SUBJECT: MEETING SUMMARY - TRAINING MANAGERS' CONFERENCE CONDUCTED  
ON NOVEMBER 5, 1998 - H. B. ROBINSON STEAM ELECTRIC PLANT

## TRAINING AND OPERATIONS MANAGERS' CONFERENCE

ATTENDEES AT THE NRC REGION II  
TRAINING MANAGERS CONFERENCE  
NOVEMBER 5, 1998

## F-0.2

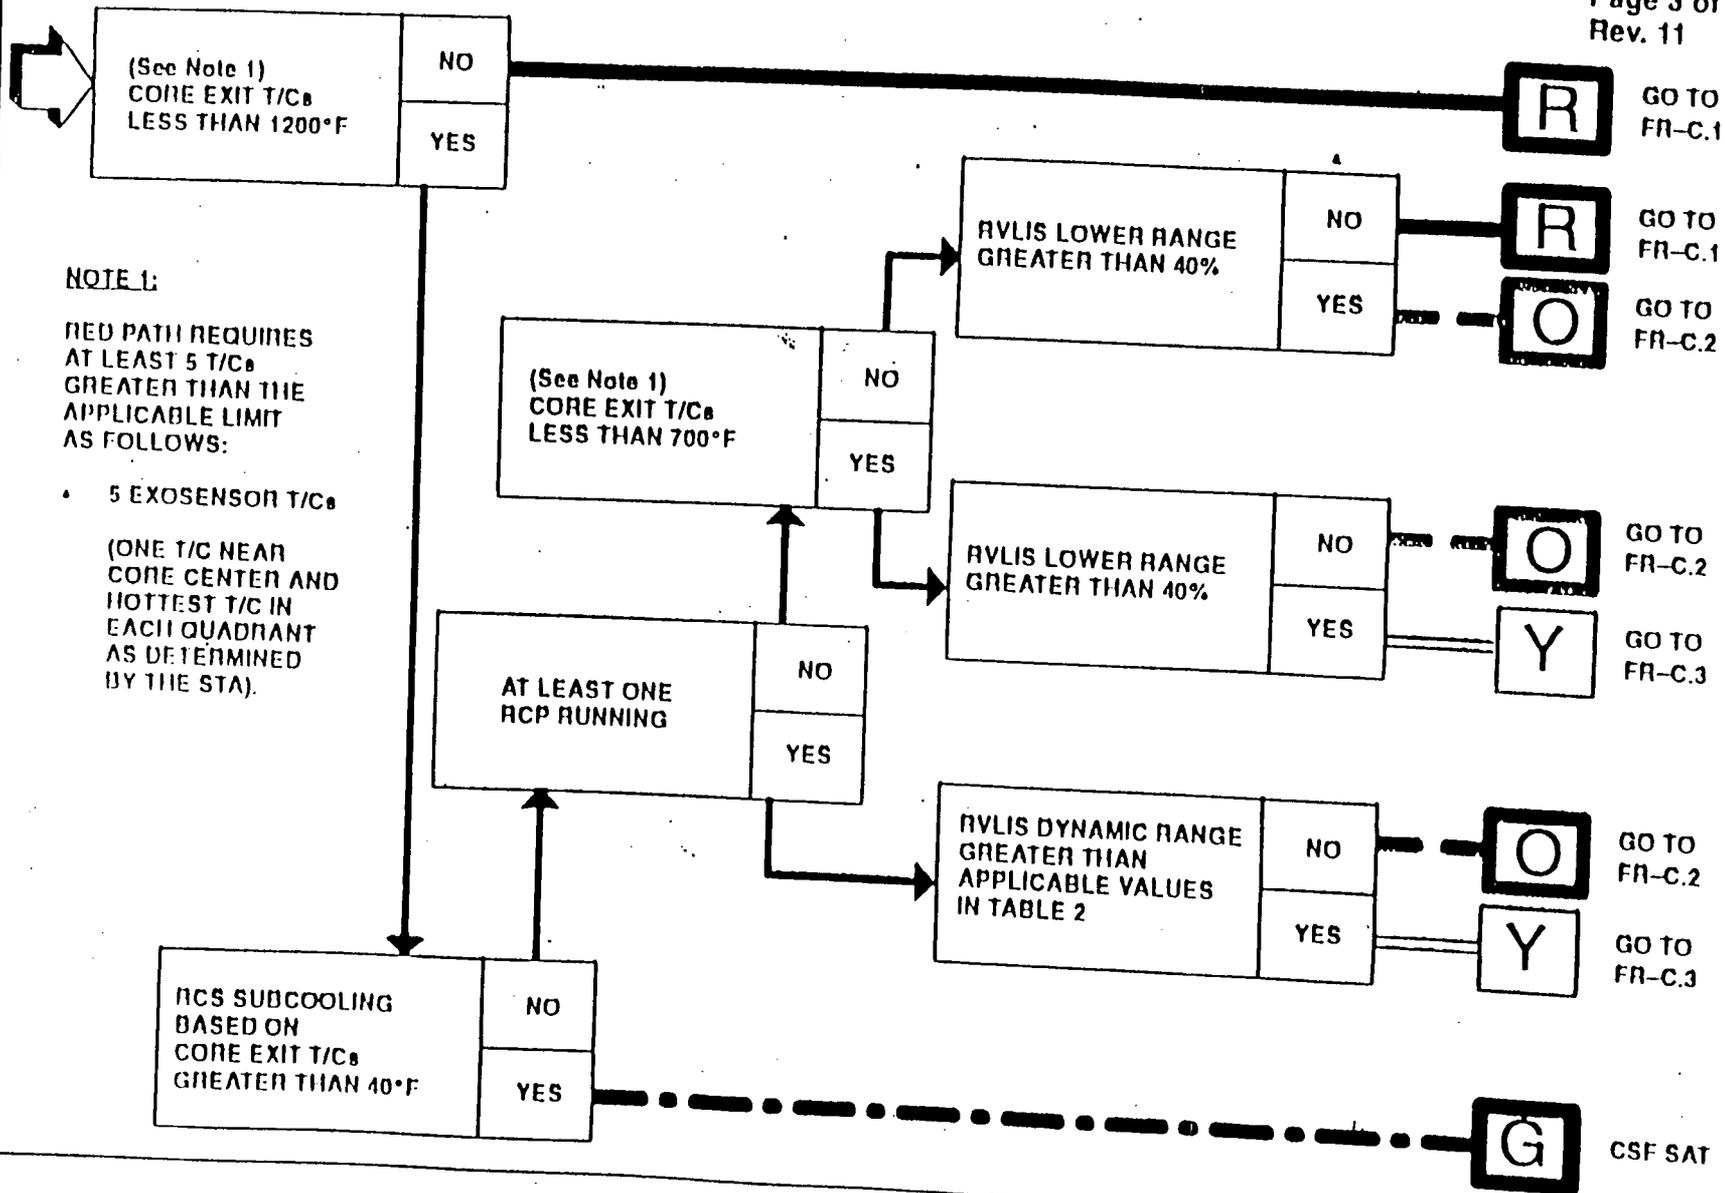
*does not agree with  
FR-0.2*
